East Branch DuPage River Trail

Great Western Trail to Butterfield Road

Steering Committee

Meeting #3 Summary

Segment 3

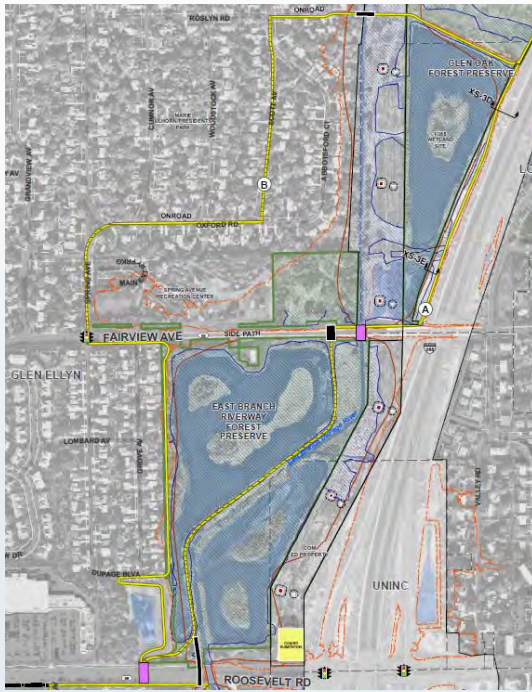
- Alternative A is located at the toe of the I-355 embankment. The existing noise wall is located at the top of the embankment and higher than the proposed trail alignment. Alternative A is anticipated to be located entirely within Tollway right-of-way. Prior conversations with the Tollway revealed that a future add-lanes project is unlikely to impact a trail facility here.

- Alternative A has a 10-year level of flood protection but impacts wetlands. Those wetlands are located in a mitigation facility for I-355.
- Alternative B is an on-road, signed route along Roslyn Road, Scott Avenue, and Oxford Road. The route would transition into a separated side path along Spring Avenue. This route provides a 100-year level of flood protection, but it would require a bridge structure over the EBDR at Roslyn Road. Due to ComEd vertical clearance restrictions, any proposed bridge would only provide a 2-year level of flood protection.

- Glen Ellyn noted that Alternative B may deviate from the alignment shown in the plan. Scott Avenue has several large grade changes that may be difficult for cyclists to navigate.

- The possibility of deviating Segment 3's route was discussed. The proposed deviation would allow the path to continue south across Oxford Road through residential homes and into either the Spring Avenue Recreation Center or the Glen Oak Forest Preserve. Glen Ellyn indicated that may be difficult to find sufficient space between residential lots, also noting that the area south of Oxford is a wet, low-lying area. CBBEL indicated that wetland delineations had not been conducted here, but the area appears to be DuPage County wetlands and would likely require mitigation if a trail was constructed.

- Members reiterated the Committee's preference for an off-street "greenway corridor." It was agreed that the location along the Tollway would be considered preferable for fulfilling that vision.

On the above basis, the group concurred with Alternative A (Tollway ROW) as the Segment 3 (south portion) alternative to be carried forward into Phase I Engineering for further design development and evaluation.

Segment 4 Summary

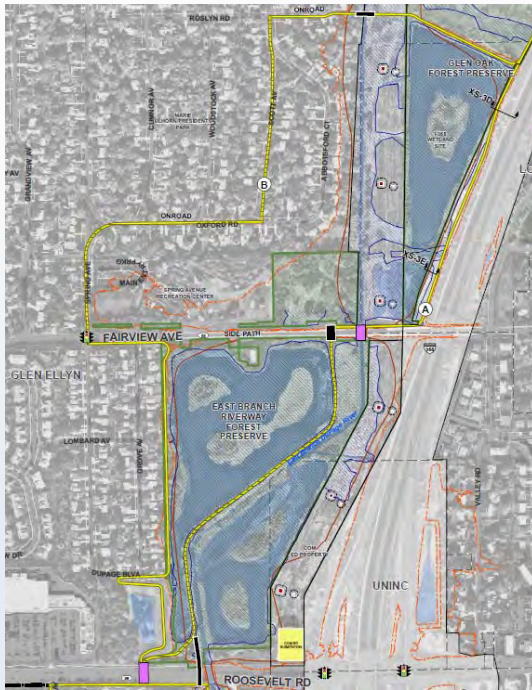
- Alternative A was previously discussed at SC Meeting #2. It is an existing user-defined trail on a berm located just west of the EBDR which separates the river from open water lakes. Two culverts hydraulically connect the river to the lakes. The existing berm provides a 2-year level of flood protection, and it is anticipated to have minimal or no boardwalk structures and minimal wetland mitigation.

- A new Segment 4 alignment, shown as Alternative B, was presented on the west side of the East Branch Forest Preserve south of Fairview Avenue (IL 53). The alignment is routed along the west bank of the East Branch Forest Preserve's open water behind the back yards of many residences and has a 10-year level of flood protection.

- North of Roosevelt, Alternative B is proposed to be routed on the top of an existing private detention basin berm in order to avoid open water. The berm is significantly higher than the adjacent low-lying forest preserve, and it may provide a good user experience with views of the

forest preserve along the berm. However, partial or full land acquisition of the detention basin would be necessary to construct and maintain the path. The cost may be significant.

- FPDDC indicated a preference for Alternative A over Alternative B, and offered a variation of Alternative B south of Roosevelt. That variation could utilize Spring Avenue to avoid potential trail switchbacks.
- Glen Ellyn indicated local road routes may be feasible south of Fairview.

On the above basis, the group concurred with Alternative A (Middle Berm) as the Segment 4 alternative to be carried forward into Phase I Engineering for further design development and evaluation.

Boardwalks Opportunities

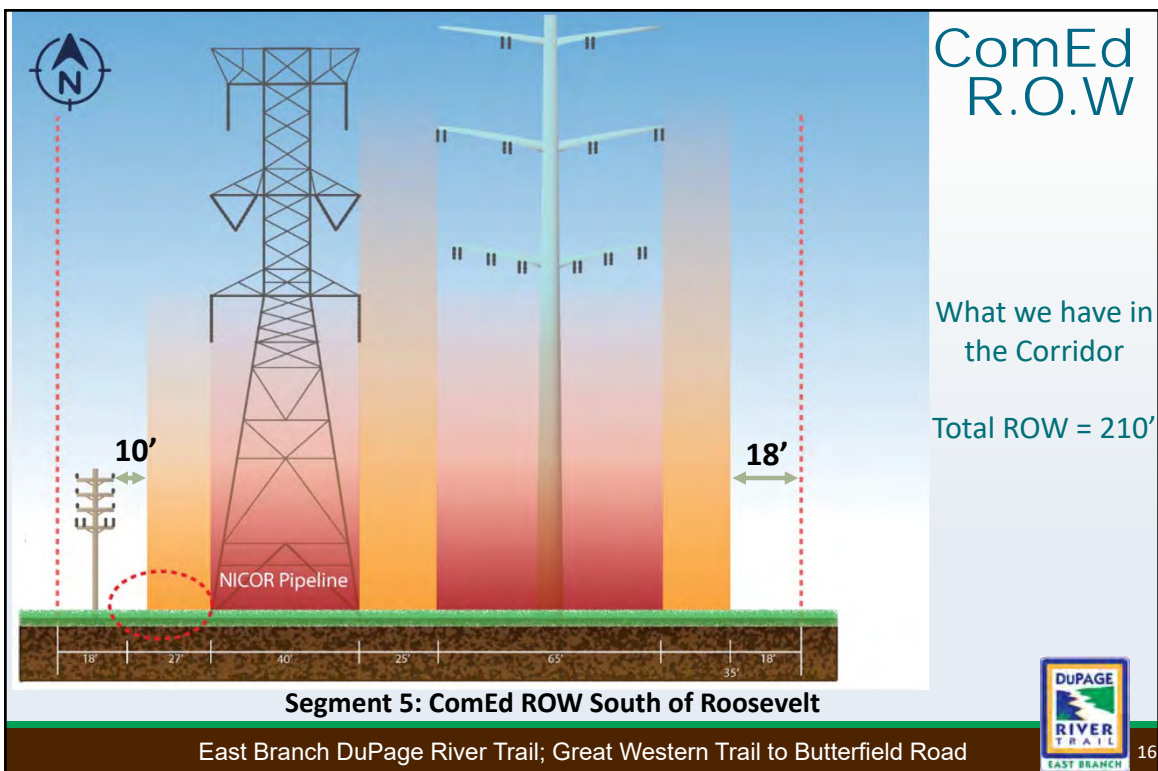
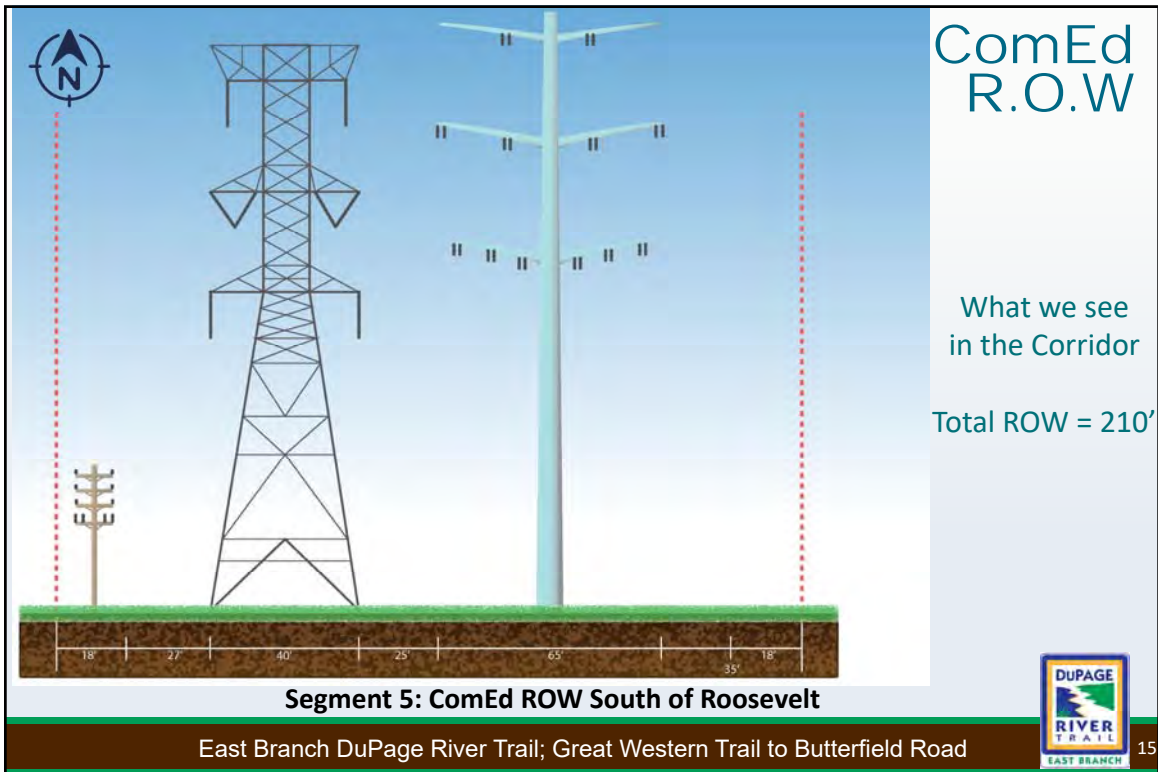
- General topics were brought up during the discussion that apply to the entire corridor. Further research was completed on types of boardwalks or pedestrian bridges. Several boardwalk manufacturers were contacted and confirmed that “top-down” construction of HS-20 boardwalks was possible, although time consumptive. This method greatly reduces the construction footprint, and essentially eliminates all temporary wetland impacts normally part of the construction process. The approximate costs of the boardwalk structures were confirmed and presented as \$200/SF for the HS-20 loading, as well as lesser design costs. Boardwalks can be made out of concrete slabs, Corten steel, or other very robust materials.

Segment 5 Summary

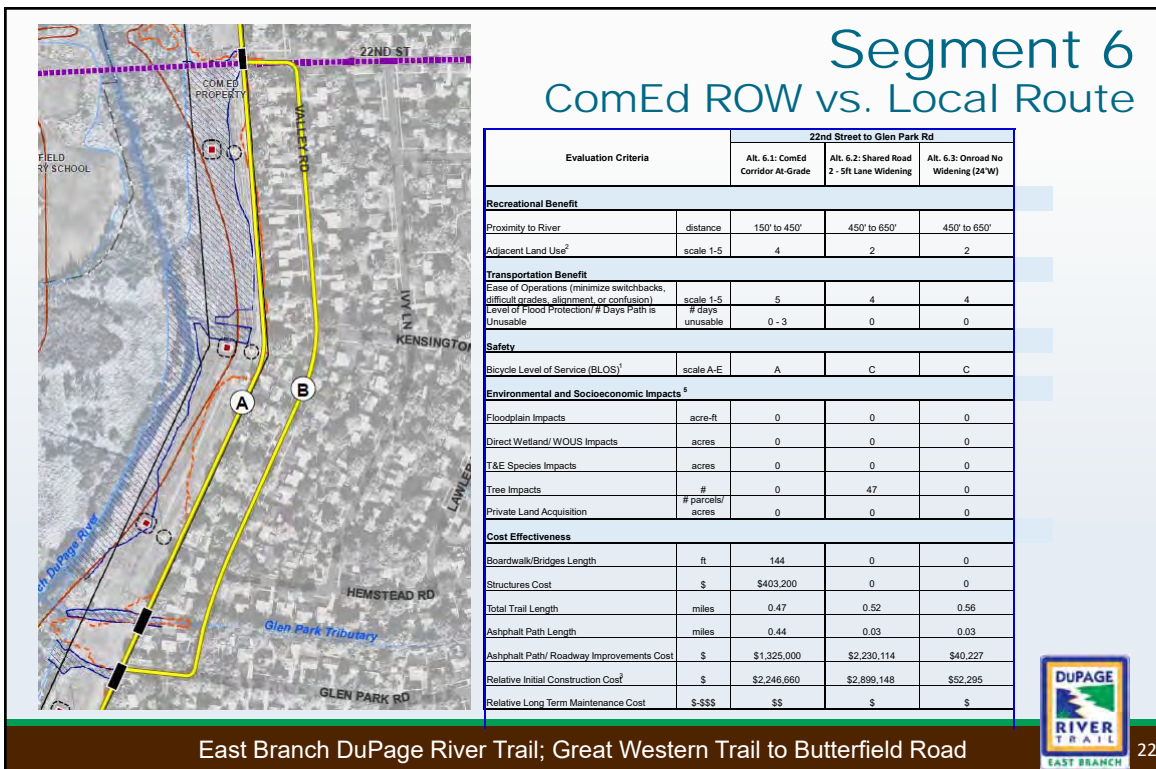
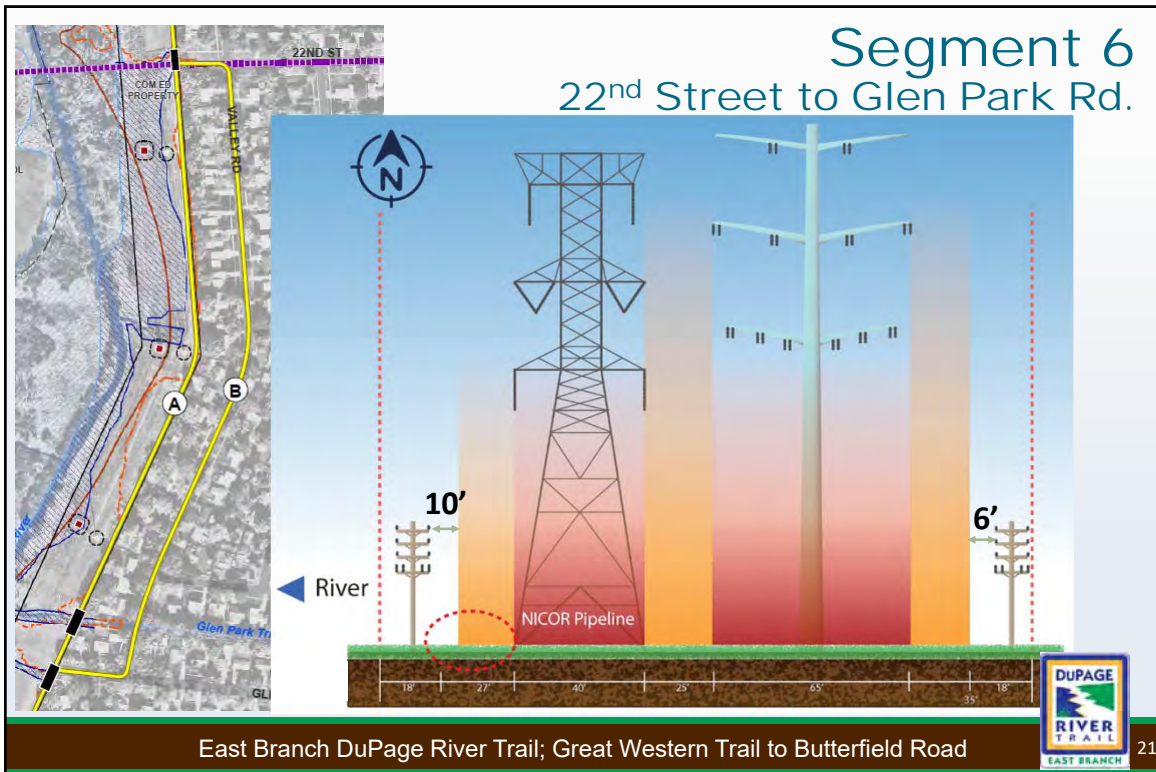
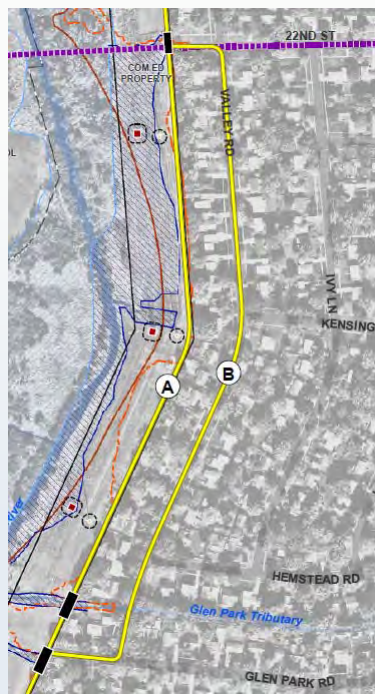
- Alternative A is generally along the ComEd Corridor located west of I-355. Alternative A crosses the East Branch DuPage River just south of Chapel Ct South Dr. The EBDRT remains west of the ComEd corridor until IL 56.

- Alternative B is a local on-road route proposed to be a side path traversing west along the south side of Roosevelt Road, southwest along the northwest side of Pershing Avenue, cross the east leg of Pershing Avenue, south along the east side of IL 53, east along the north side of Glenbard Road, and either an on-road or side path south along Sunnybrook Road. An off-road path would traverse east along the north side of the Glenbard Wastewater Authority property and cross the EBDRT to return to the ComEd corridor.

- Previous conversations with ComEd about their design requirements were summarized for the Steering Committee. The summary included minimum loading requirements, projected cost implications, clearances, height restrictions, and maintenance access requirements.

- Surface elevations within the corridor are low for flood protection. In many cases, the existing ground surface provides a level of flood protection below a 2-year storm level. Further, no raised construction vehicle beds are allowed within the clearance zone, making construction of the trail more costly and less expedient. Any portion of the EBDRT constructed within the ComEd tower clearance zone (17 feet outside the outer-most tower wire) cannot exceed the existing ground elevation. Any part of the EBDRT built within the tower wire clearance zone must be built at-grade or lower.

- The County indicated that due to construction and maintenance constraints, the Division of Transportation would not be considering any alignments within the ComEd clearance zones. That leaves approximately 18 feet of width on the east-most side of the ComEd corridor.

- Alternative A is outside the ComEd clearance zone but presents significant challenges. The existing low-lying area has extensive wetlands, which would require wetland mitigation and compensatory storage mitigation if a trail were constructed on berm. Alternative A features a proposed hybrid boardwalk and berm structure that could be built to minimize wetland impacts, minimize impacts to the floodplain, and provide a cost-effective solution.

- A Steering Committee member suggested altering the route of Alternative B to a route on Maryknoll Circle in order to connect to Glenbard Road via an existing neighborhood private path. It was determined that further coordination with the Maryknoll homeowners' associations would be needed to evaluate the efficacy of that option. Glen Ellyn offered to lead discussions with Maryknoll.

- Glen Ellyn indicated safety concerns about Alternative B, specifically related to steep grade changes and poor sight distance. It was recommended to be a separated side path facility in some locations such as Glenbard Road. Other local on-road routes could be considered, though.

- It was noted that the Glenbard Wastewater Authority may be open to dedicating property for the proposed EBDRT to traverse east over the EBDR. A new structure would be necessary to cross the EBDR.

On the above basis, the project team will evaluate an alternative Segment 5 and 6 western alignment and coordinate with the appropriate agencies for review.

Segment 6 Summary

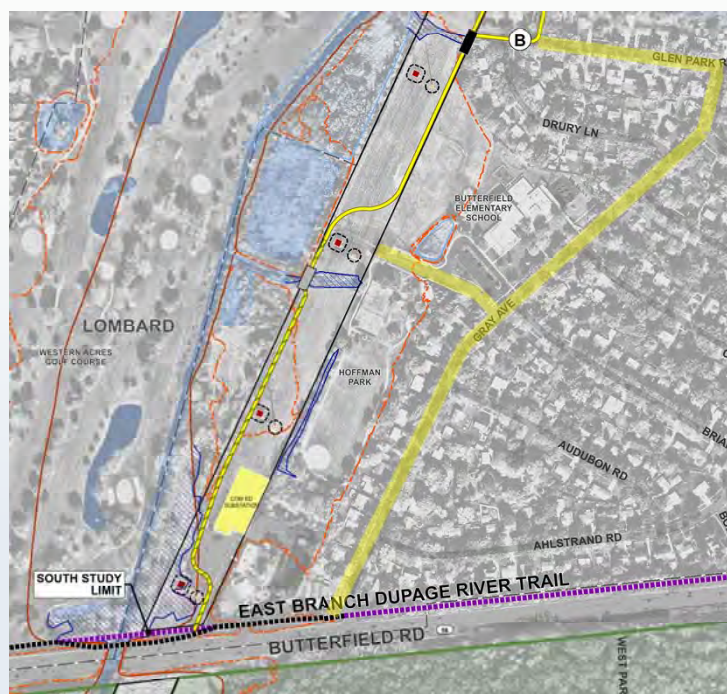
- Alternative A utilizes the ComEd corridor.
- Alternative B is an on-road alternative. Like other on-road options, Alternative B could be a side path or a signed on-street route. It would provide a 100-year level of flood protection.
- South of 22nd Street, the ComEd right-of-way available width is reduced even further with distribution poles on the east side of the corridor to 6-feet wide.
- Alternative B along Valley Road was discussed for its efficacy for detailed analysis in Phase I. It was acknowledged that the alignment shown within the ComEd right-of-way from Glen Park to Butterfield presents even greater challenges than Alternative A of Segment 5 with regards to clearance zones, constructability, and maintenance constraints.

South of Roosevelt IL 53 Sidewalk

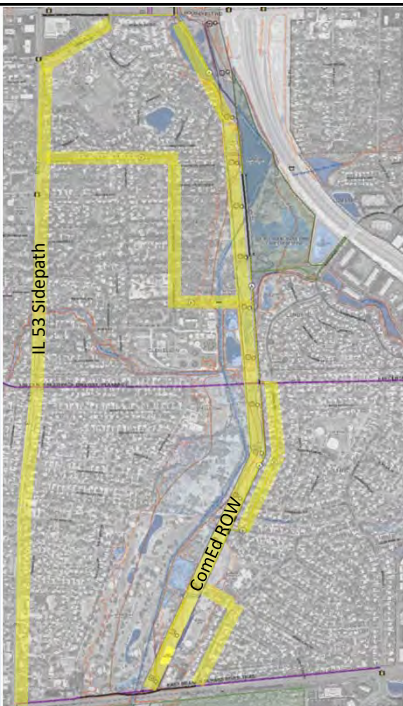
- Another option that was discussed was a side path facility along IL 53 from Roosevelt to Butterfield. Any side path would require consideration of a future IL 53 widening project, steep grade changes within the corridor, and drainage facility improvements.

- Several Committee members expressed potential concerns about a IL 53 side path option. Some of the concerns that were raised include availability of right of way, the possibility of a future widening project, safety, grade changes, and drainage improvements.
